MFN 07-295
June 8, 2007

Subject: **GE Response to NRC, "Request For Additional Information Related To Advanced Boiling-Water Reactor Licensing Topical Report (TAC NO. MD4025)," Regarding Alternate RCIC Turbine-Pump Design**

**Licensing Topical Report NEDE-33329P
“Advanced Boiling Water Reactor (ABWR) With
Alternate RCIC Turbine-Pump Design”**

DRG NO.C.NO-000721

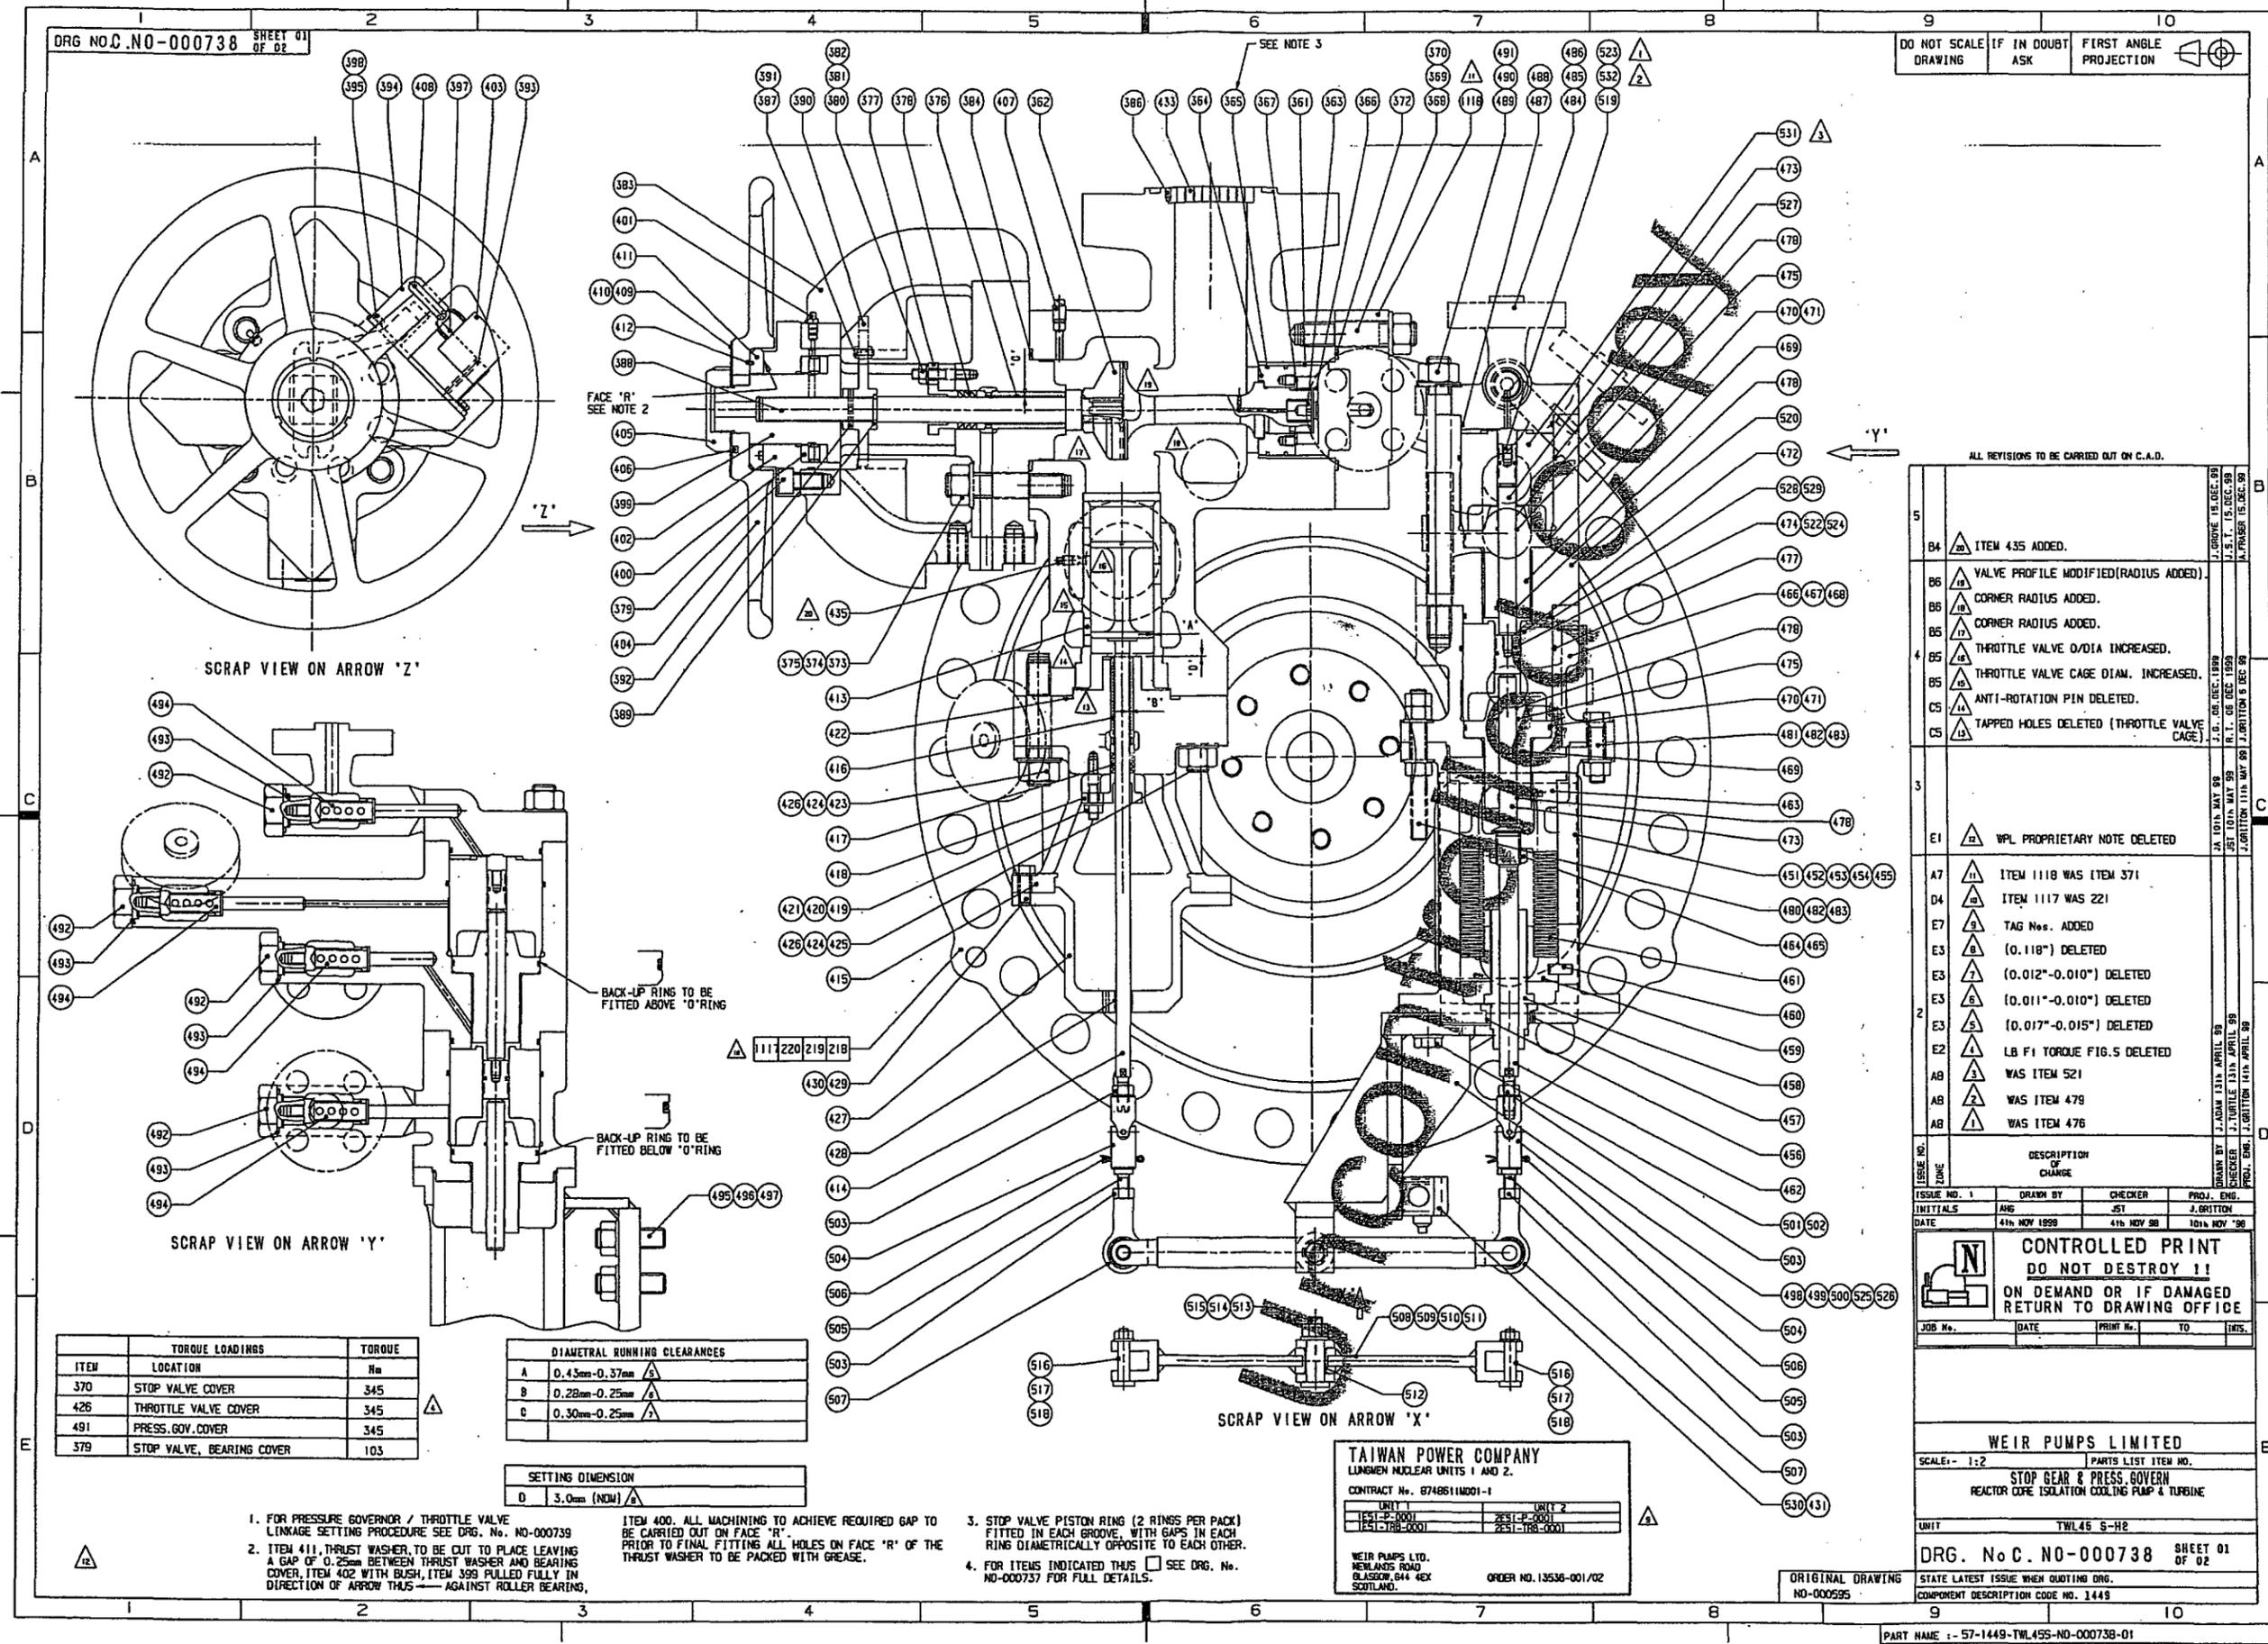
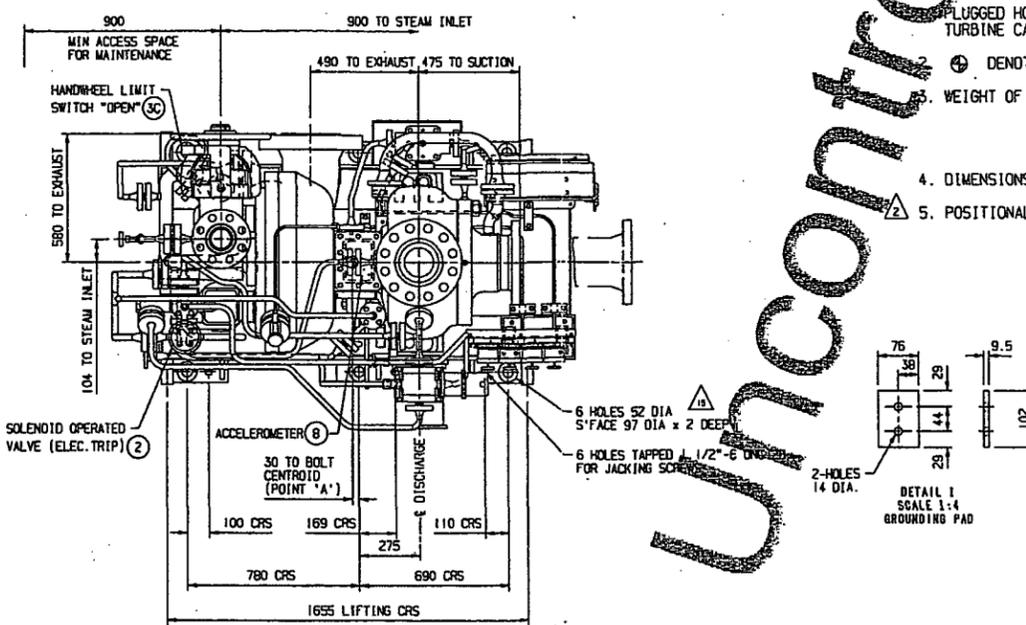
Figure 1, "TWL Type Turbine-Pump Assembly," on page 11 in NEDE-33299P provides a rough drawing of the alternate RCIC turbine-pump design. Provide a more clear detailed diagram and/or photographs of the alternate design showing the inlet, outlet, connecting lines, and instrument locations.

To assist in NRC review, detailed engineering drawings of the alternate RCIC turbine-pump design are attached in Enclosure 2.
